UNITED STATES  
DEPARTMENT OF THE INTERIOR  
BUREAU OF LAND MANAGEMENTFORM APPROVED  
OMB NO. 1004-0137  
Expires: January 31, 2018**SUNDRY NOTICES AND REPORTS ON WELLS**  
**Do not use this form for proposals to drill or to re-enter an abandoned well. Use form 3160-3 (APD) for such proposals.**5. Lease Serial No.  
NMLC063875

POKER LAKE UNIT 27 BD 107H

XTO Permian Operating, LLC, requests permission to make the following changes to the original APD:

## PECOS DISTRICT DRILLING CONDITIONS OF APPROVAL

*Note: Picture below highlights BOP components that will be tested during batch operations*

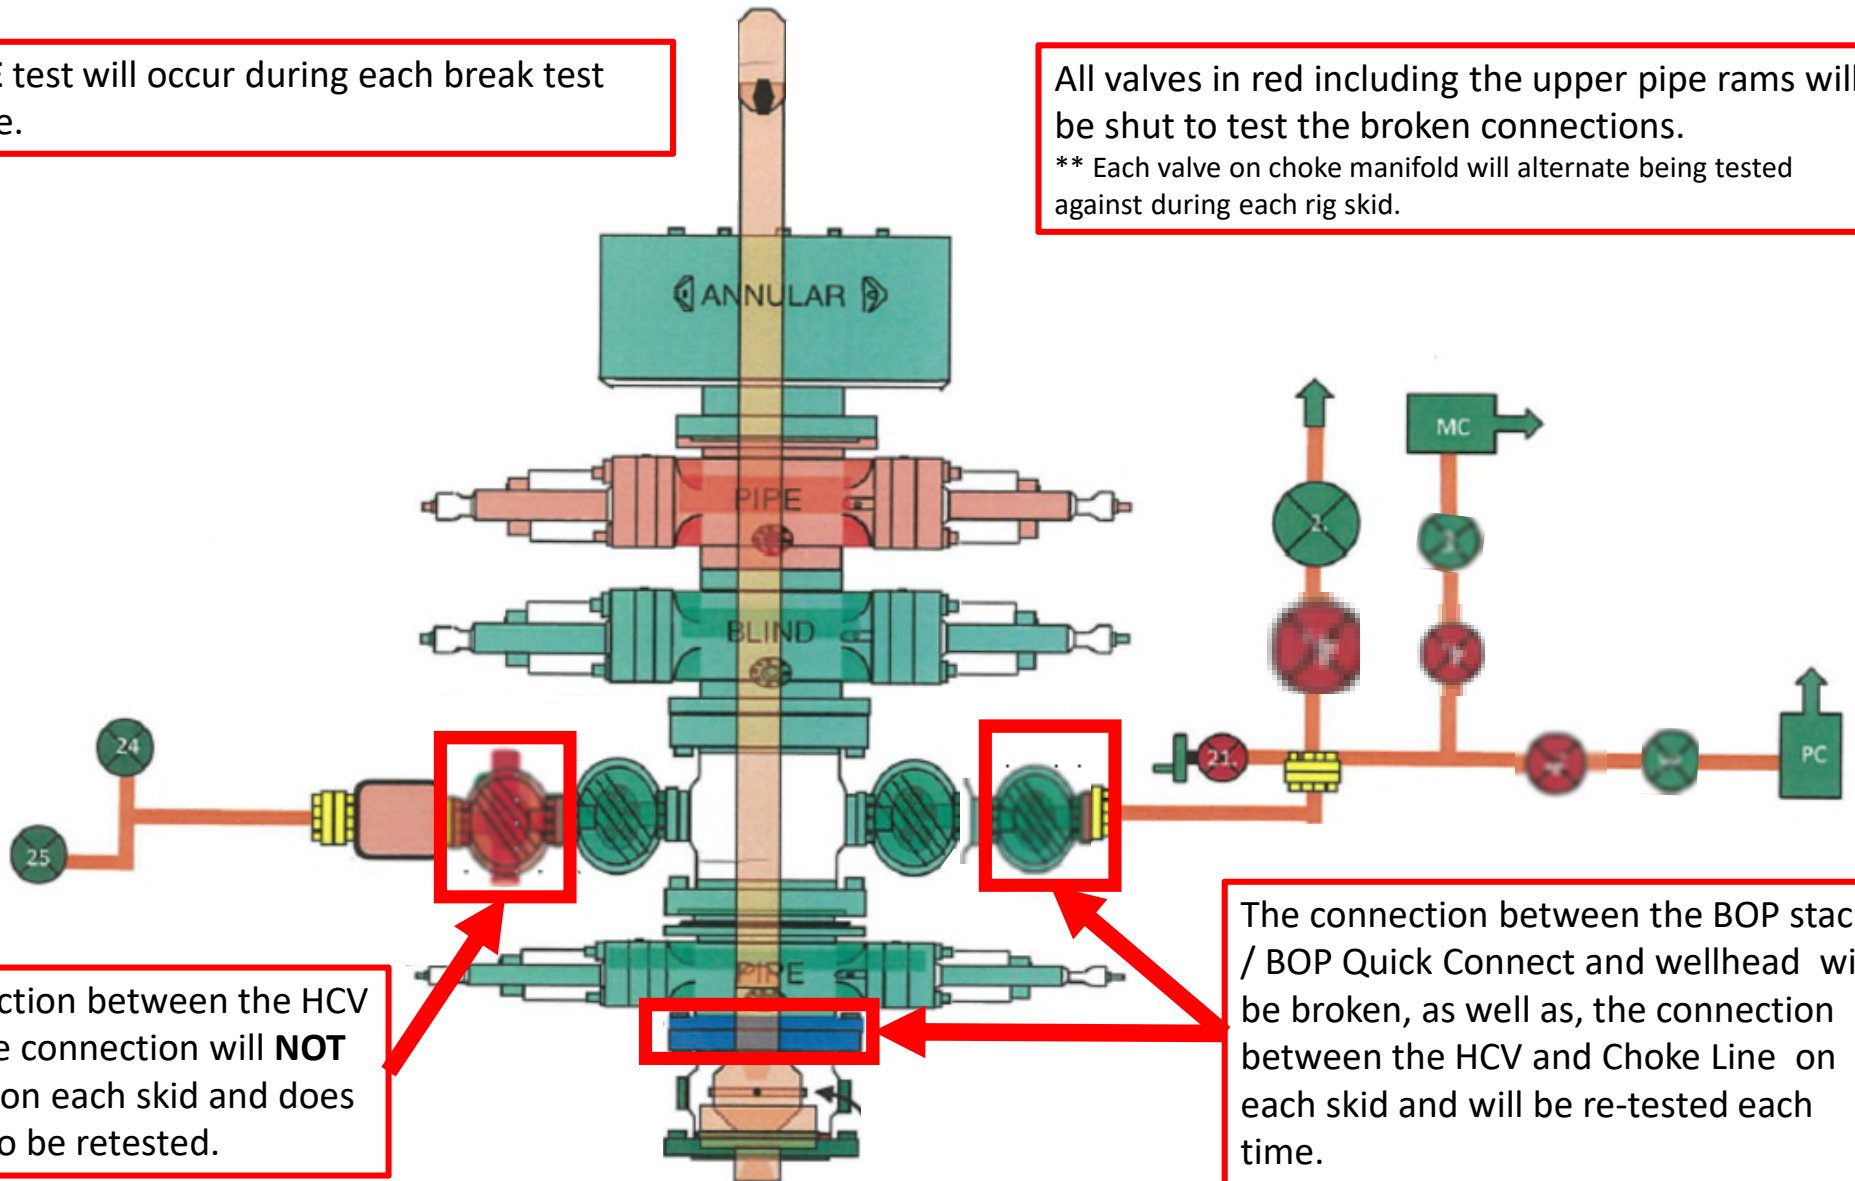
All valves in red including the upper pipe rams will be shut to test the broken connections.  
\*\* Each valve on choke manifold will alternate being tested against during each rig skid.

The connection between the HCV and kill line connection will **NOT** be broken on each skid and does not need to be retested.

The connection between the BOP stack / BOP Quick Connect and wellhead will be broken, as well as, the connection between the HCV and Choke Line on each skid and will be re-tested each time.
